MEETING:	PLANNING AND REGULATORY COMMITTEE
DATE:	3 SEPTEMBER 2025
TITLE OF REPORT:	243045 - PROPOSED ERECTION OF 31 NO. KEY WORKER DWELLINGS, INCLUDING ACCESS FROM CLUBTAIL DRIVE WITH ASSOCIATED INFRASTRUCTURE AND LANDSCAPING – LAND OFF CLUBTAIL DRIVE, HOLMER, HEREFORD. For: Bloor Homes Western per Mr George Elston-Bates, 3 Rd Floor, Regent House, 65 Rodney Road, Cheltenham GL50 1HX

2. AMENDED PROPOSAL

Figure 1: Amended Landscaping Scheme (Northern Parcel)

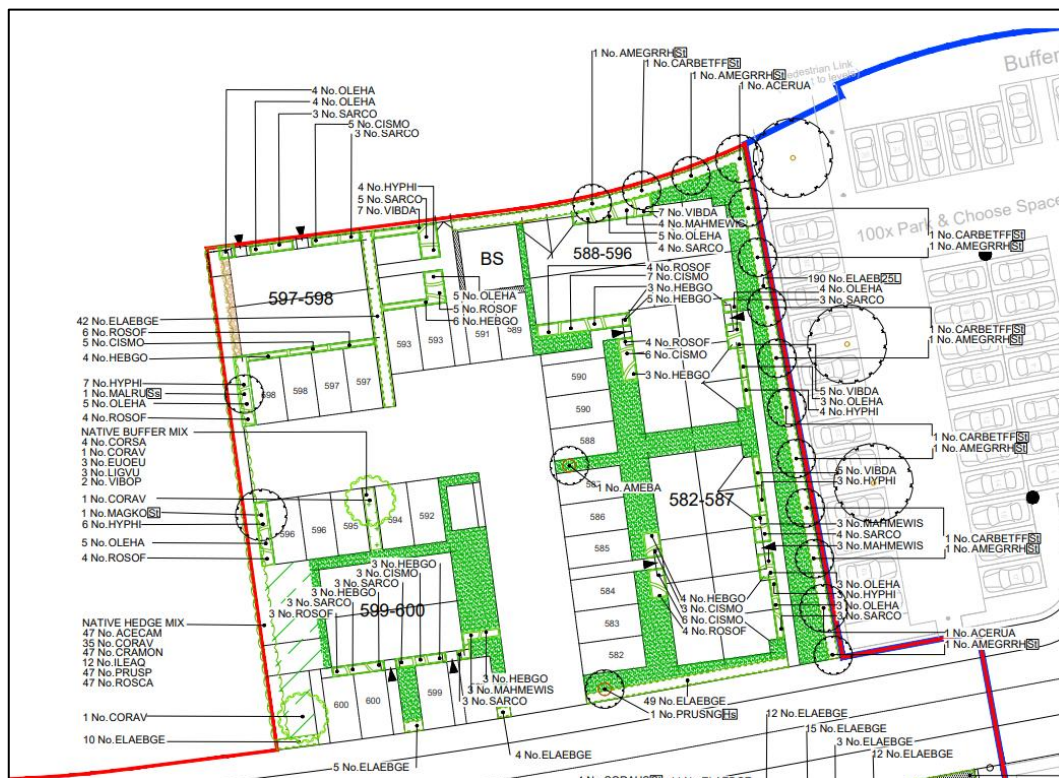
- 2.4 The amended landscaping plan for the relevant section of the site is shown at Figure 1. Updated visualisations for this section of the site, including views from Hedgerow Way and the A49 to the north-east are shown at Figures 2 and 3.

Along the boundary with the car park, there is an ornamental evergreen hedge (*Elaeagnus x ebbingei*), with alternating small, narrow tree species (*Carpinus betulus* 'Frans Fontaine' and *Amelanchie x grandiflora* 'Robin Hill'). There are a different species on the corners (*Acer rubrum* 'Armstrong'). This is suitable to soften the boundary and provide some green infrastructure to benefit both wildlife and particularly pedestrians using the path to access front doors.

I would recommend that details of the planting area and specification are added as a condition to be agreed prior to planting being carried out. The tree pit and planting pit detail provided are standard, however given the narrow strip of land here, a site specific detail should be provided. This should combine the grass verge, hedgerow and tree pit as a trench to maximise the available root volume for them all to grow together. It should show details (in both plan and section) of kerb / edging stones and associated foundations, and the timber post and rail fence + metal estate railing, as this also takes up underground space. Consider whether any underground root barriers are required along the car park side. It should also take consideration of watering points for establishment and long term maintenance. Given the adjacent site has been used as a construction compound the ground is therefore likely to be highly compacted, and therefore details of drainage should also be provided.

With the exception of site clearance and groundworks, no further development shall commence until a bespoke plan and planting specification for the trees, hedgerows and shrubs along the eastern and northern boundary of the site (adjoining the Adeline and Albany units) has been submitted to and approved in writing by the Local Planning Authority. The scheme shall include the following:

- a) A site-specific planting trench design in both plan and section, showing integration of tree pits, hedgerow and grass verge to maximise root volume.
- b) Details of kerbs/edging stones and their foundations, and the alignment of boundary treatments including the timber post and rail fence and metal estate railing.
- c) Provision of root barriers where necessary (particularly on the car park side).
- d) Arrangements for watering points for establishment and long-term maintenance.
- e) Specification for imported planting soil, including details of preparation of existing soil to address potential compaction caused by use of land as construction compound.
